FINAL MCDONALD ROAD SIDEWALK FEASIBILITY STUDY

APRIL 2015

Response to FDOT Comments

MAP 2 - INTERSECTION OF MADELINE AVENUE AND SUGAR HOUSE DRIVE

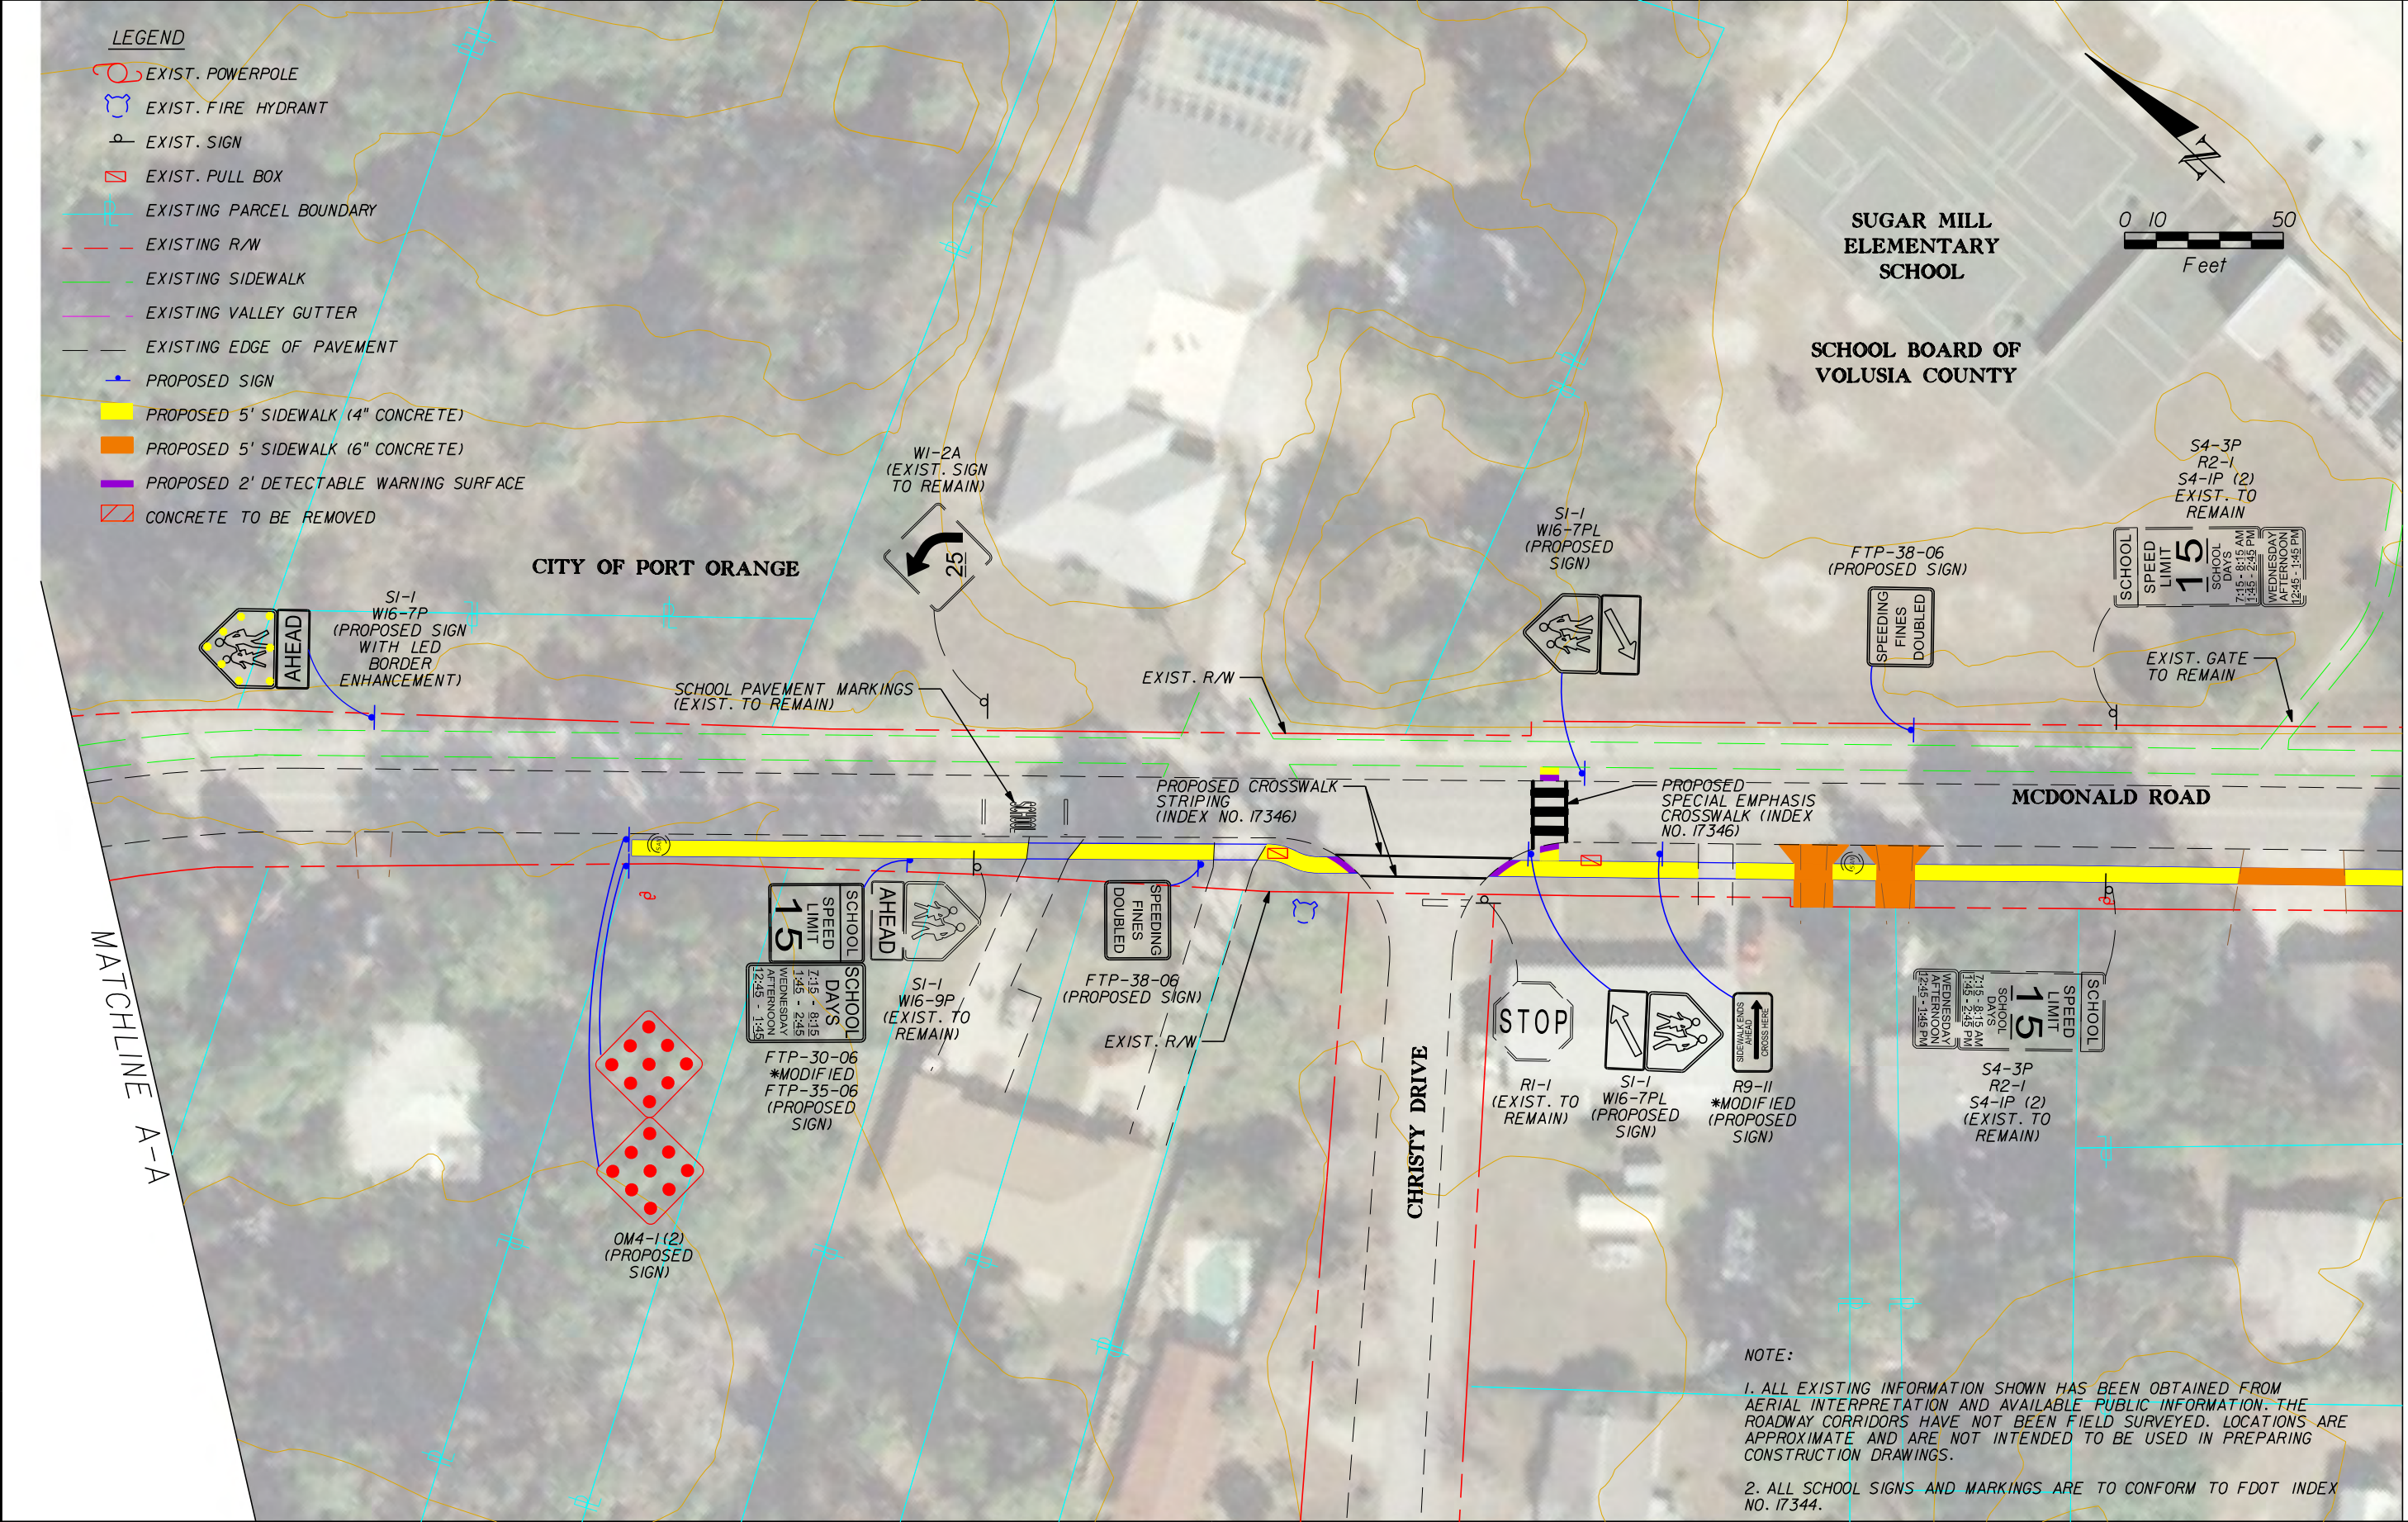
Comment #1: Curb and gutter at Madeline Ave/McDonald Road at Sugar House Drive:

Comment #1A: On page 15, the study mentions the existing sidewalk cannot be offset from the roadway because of the existing ditch. The study recommends curb and gutter be placed to provide a barrier for pedestrians. Curb and gutter **should not** be used for applications other than drainage conveyance, per the Department.

Comment #1B: Priority would be to relocate the sidewalk at/or nearest to the R/W line. Have piping the ditch, pushing the sidewalk back to the R/W, and utilizing walls (if necessary) been thoroughly reviewed for feasibility?

Response: The recommendation for curb and gutter has been removed from the conceptual alignment.

Response: This area is part of a larger drainage system, and piping the ditch is not recommended at this location. The conceptual recommendations have been revised to include a gravity wall and pedestrian railing at this location. Recommendations have also been made to move the existing utilities to provide extra clearance for the sidewalk.
